Date: 02 May 2025

Respond to Request Further Information 2 September 2024

Private Plan Change Request (Ref: PC0003/23) – Coniston Park Ltd, Farm & Racecourse Roads, Ashburton

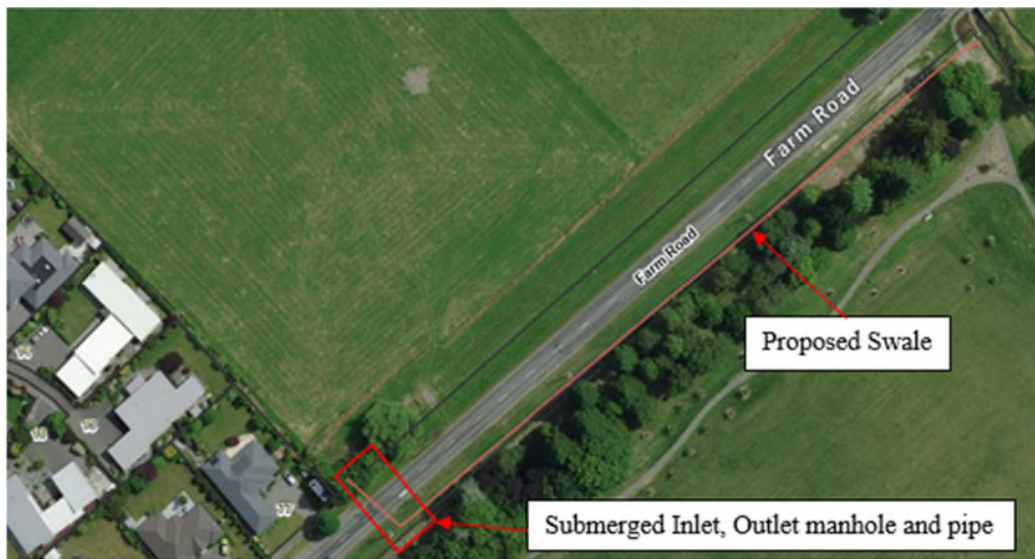
c. First flush treatment depth is 18mm for the Council’s global consent – not 25mm.

The first flush depth to be designed to 18mm.

INFILTRATION BASIN TYPICAL CROSS SECTION

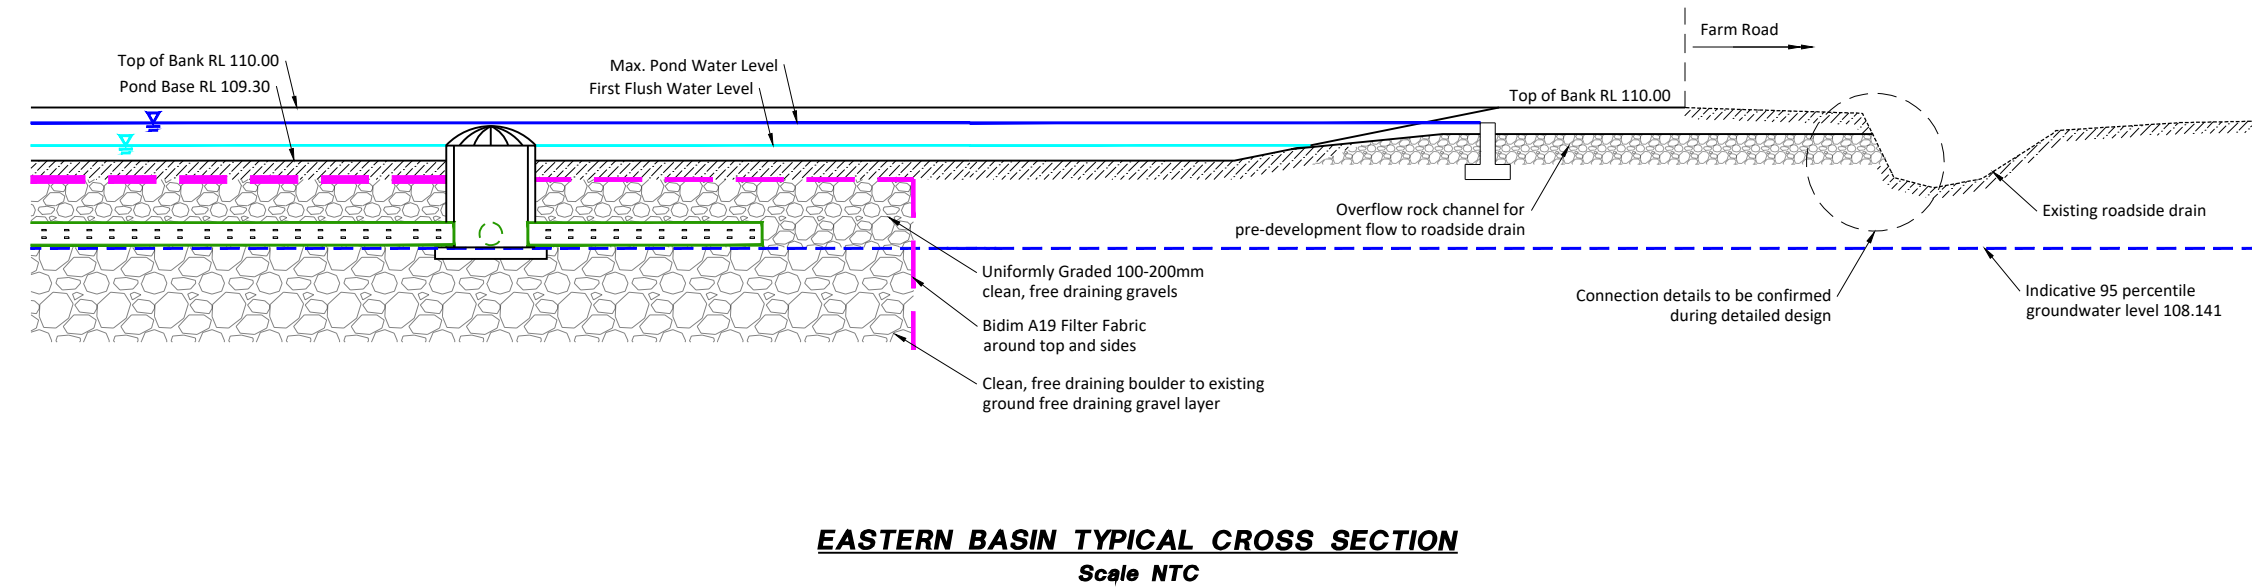
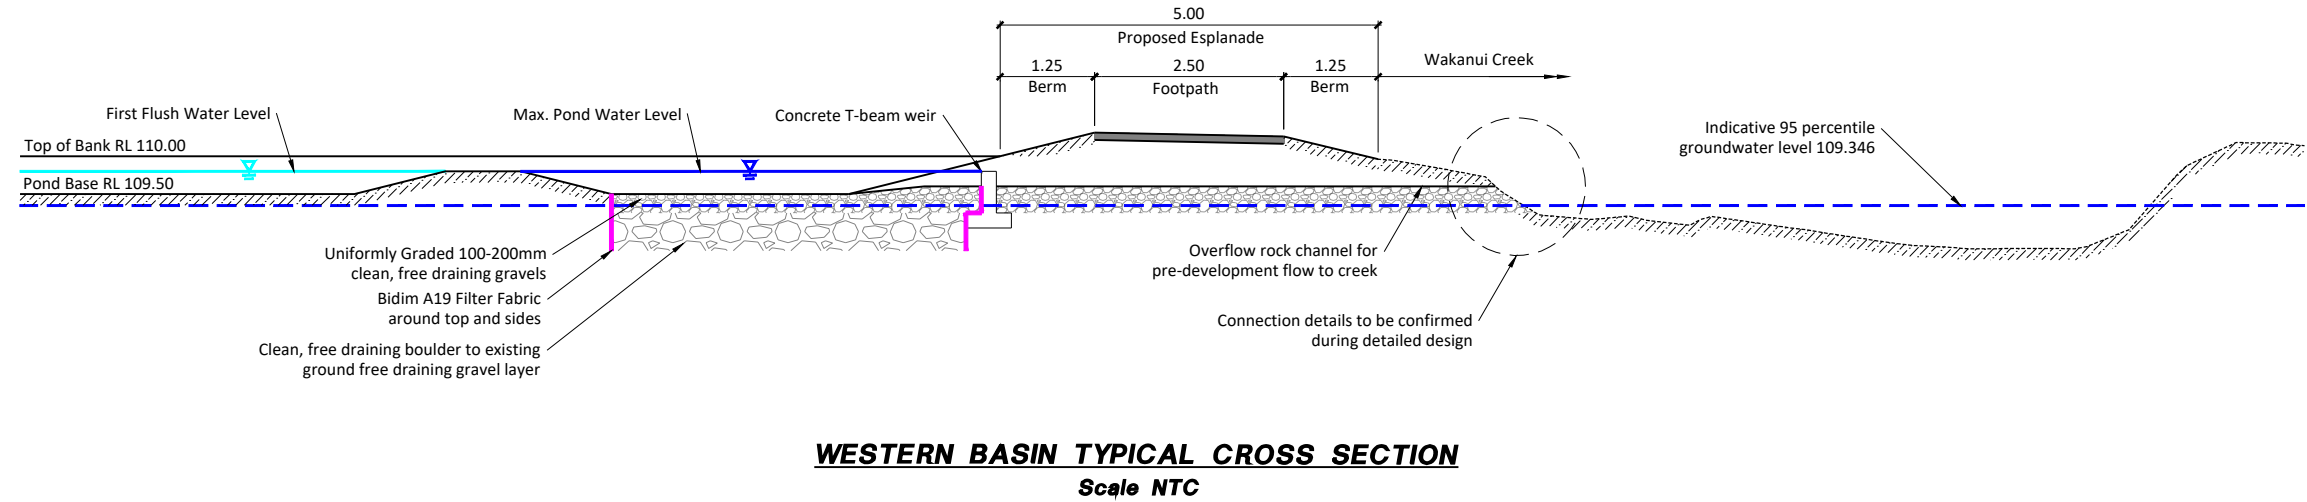
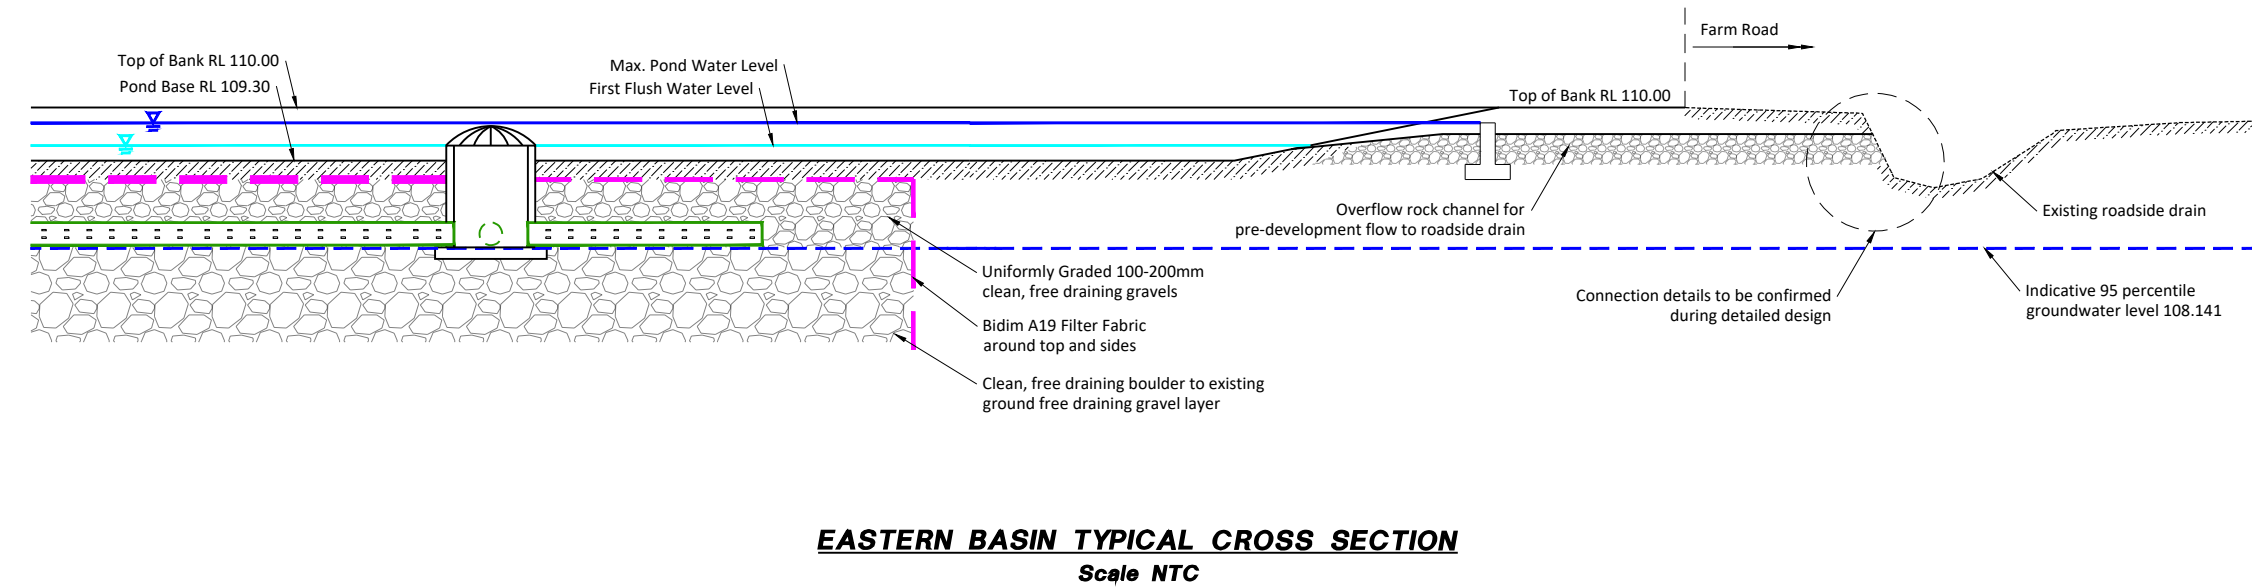
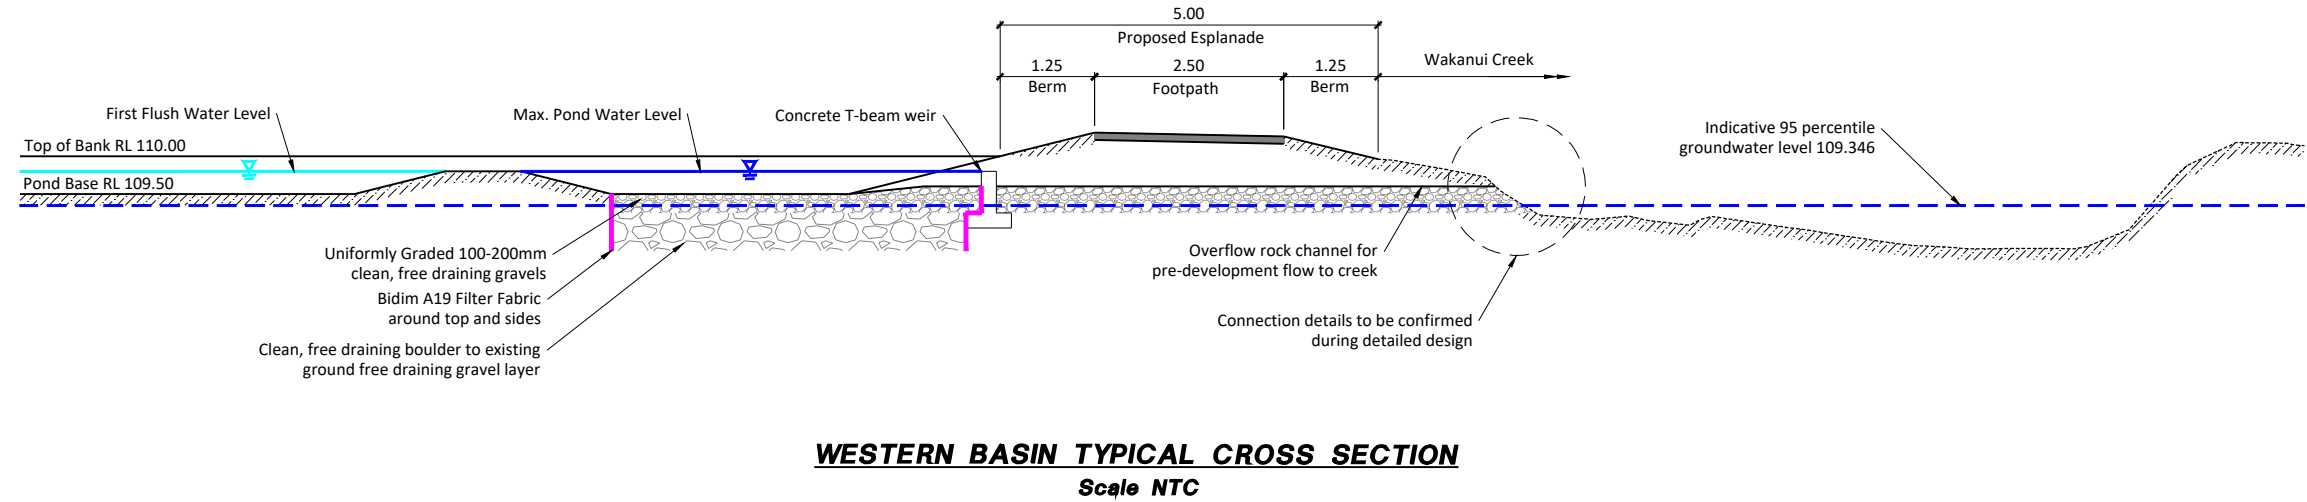
6. Confirmation of the separation between any soakage from the SHWT. (1m is likely required for the global consent, but a smaller separation could be accepted from the historically high groundwater level.) The current drawings show that the rapid soakage has existing groundwater level within the middle of the soakpit, which is effectively negative separation to groundwater.

As shown in the cross-sections of both the western and eastern stormwater ponds, it is unlikely that sufficient separation can be achieved from the 95th percentile high groundwater level.

According to the Geotechnical Report, the proposed development site contains a thick clay layer (greater than 1.5 m in depth) across the site before reaching the underlying drainage layer. For the soakage system to function effectively, it must extend to suitable drainage layer in order to achieve the required design infiltration rate. However, the required soakage depth will result in a no separation from the 95th percentile high groundwater table.

However, the stormwater being discharged will have undergone treatment and will not exceed the contaminant limits set by the LWRP. Furthermore, this discharge occurs after the first flush volume and will be further diluted, ensuring contaminant concentrations remain below LWRP limits.

Please refer to Appendix B - Plan PS01 – Infiltration Basin Typical Cross Section for the groundwater level, soakage, pond base, existing drain and creek levels.
